Field Service Bulletin F9800_01_01

Products Affected: F9800_01_01

Description: When using CPU boards, which do not have the “Master Reset” ECO, the Master Reset circuitry can sometimes malfunction causing the F-9800 tuning elements to be incorrectly set.

Figure 1

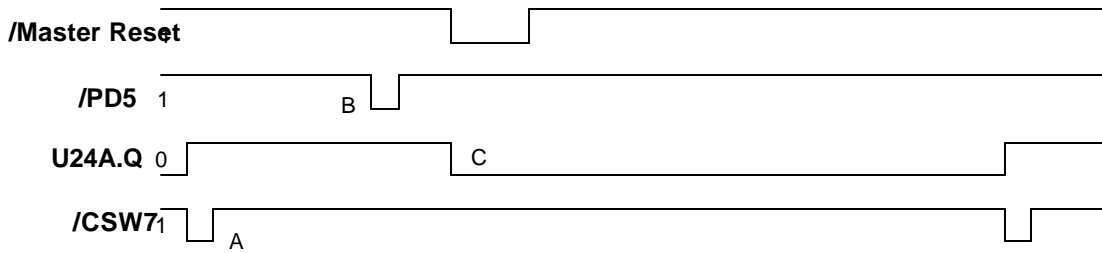
On CPU boards which have not been modified, the /PD5 pulse from the CPU has no effect since U24A is controlling the Master Reset pulse. The signal timing looks like Figure 1.

- A. /CSW7 becomes active with a series of 10 pulses as the tuning elements are being set up. This series of pulse at this time U24A.Q becomes active (going high).
- B. After the tuning elements have been set up, the CPU issues a pulse on /PD5 to trigger a Master Reset pulse. Since this pulse has no effect.
- C. U24A.Q transitions from high-to-low causing a Master Reset pulse to be generated.

The net effect is that the CPU is no longer controlling the Master Reset pulse. Under normal operation, this is not a problem. The problem occurs when the F-9800 is running its BITE test. Under this condition, there is sometimes a conflict in timing where the Master Reset pulse is still active when the tuning elements are being changed. This causes the elements to be mistuned, which in turn may cause a BITE failure. The problem can sometimes be heard as a “skipping” in the tuning relays during BITE.

Since it is possible to send frequency change information to the F-9800 faster than it can reliably change its tuning elements the following recommendations are made:

The F-9800 should not be commanded to change frequency faster than once every 200 milliseconds.

There should be a delay of at least 200 milliseconds after giving a frequency change command before giving a “Key” or “Unkey” command. This is because a Master Reset pulse is generated by the “Keying” command.

Figure 2

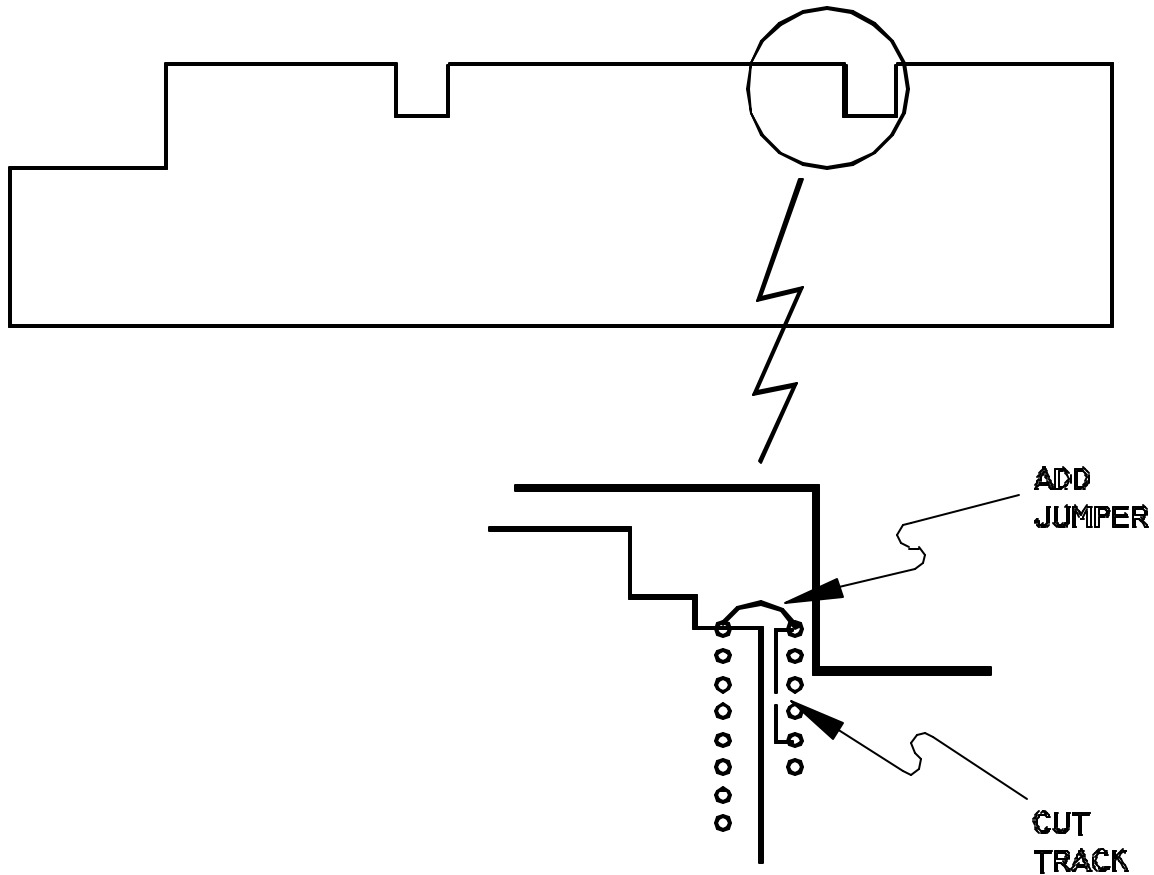
- 3) Cables J10 and P12 do not have to be removed; the board can be flipped over while they are attached.
- 4) Turn the board over, locate the area where the changes are required, please see Figure 2.

- 5.) Cut the track between pin 9 and pin 13 of U24 as shown above.
- 6.) Add a jumper between pin 9 and pin 8 of U24 as shown above.
- 7.) Replace the board back into the chassis.
- 8.) Re-connect the cables
- 9.) Replace the screws, which hold the board.
- 10.) Replace the cover.
